Controlling the combination of all penalties for the MMF PMDs

Piers Dawe

Mellanox

Estimates of budget with minor noise penalties

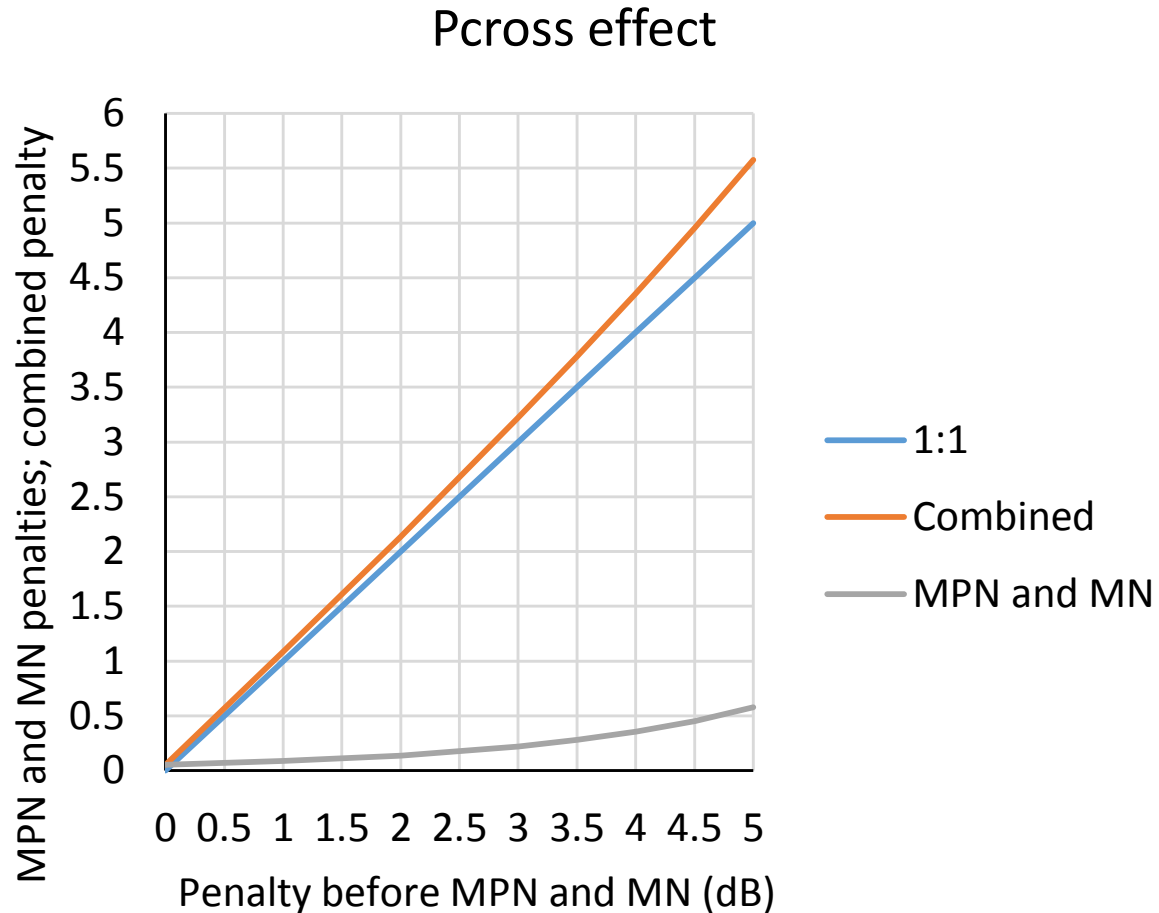
Start with the penalties and k factor in 10GBASE-SR

Compare 100GBASE-SR4
Estimated Pmpn and Pmn are very low because PAM2 and FEC

Compare P802.3cd D3.5:
implied k of 0.03 is too optimistic

In right hand columns, assume k is 0.1 or 0.075. Scale the 10G/25G noises and predict the penalties for 802.3cd MMF: around 0.4 dB, bringing the total penalty to around **4.9 dB**, vs. P802.3cd D3.5 statement of 4.6 dB
4.9 dB is too high.

Alternative remedy in context

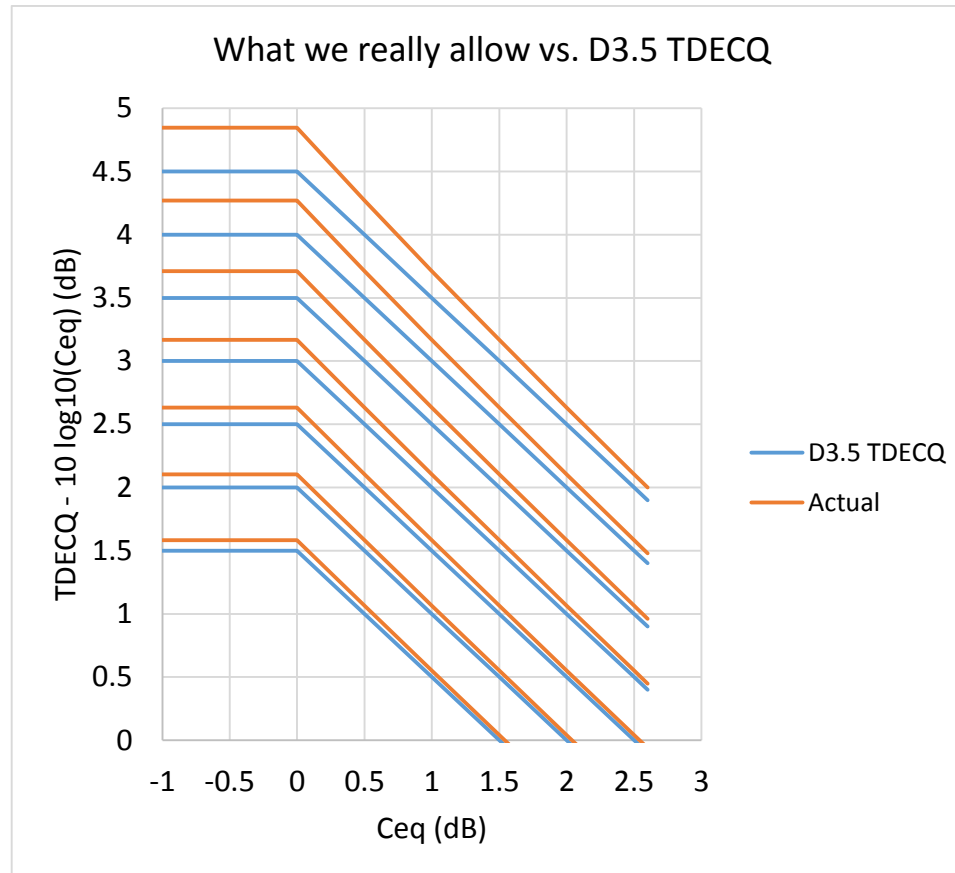
Pcross effect

MPN and MN penalties become bad only when TDECQ (without them) is bad

— Equation (138-1) is used in place of Equation (121-11).

$$R = \sqrt{(\sigma_G^2 + \sigma_S^2 - (M/C_{eq})^2)} \quad (138-1)$$

where $M = 0.0065P_{ave}$

Effect of under-estimating MN and MPN in D3.5 – without their noise enhancement

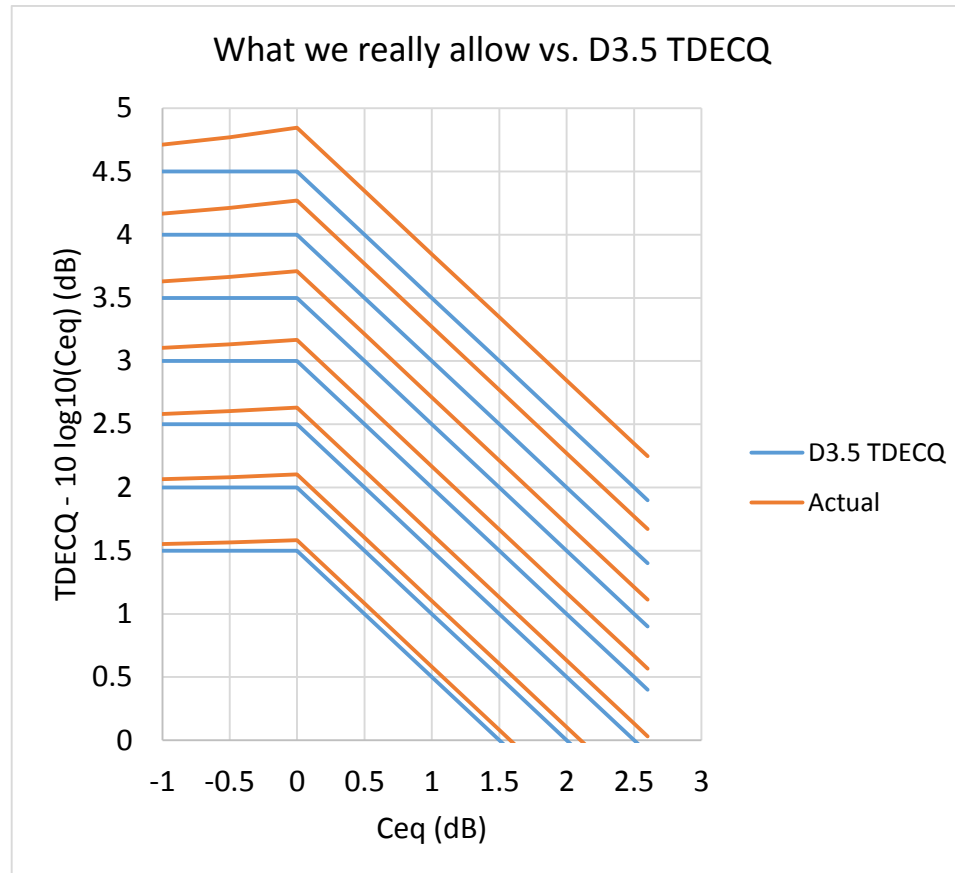
D3.5 measures the blue lines

In service receiver may experience the orange lines

Significantly worse penalty when TDECQ is bad

This slide assumes these noises do not undergo noise enhancement
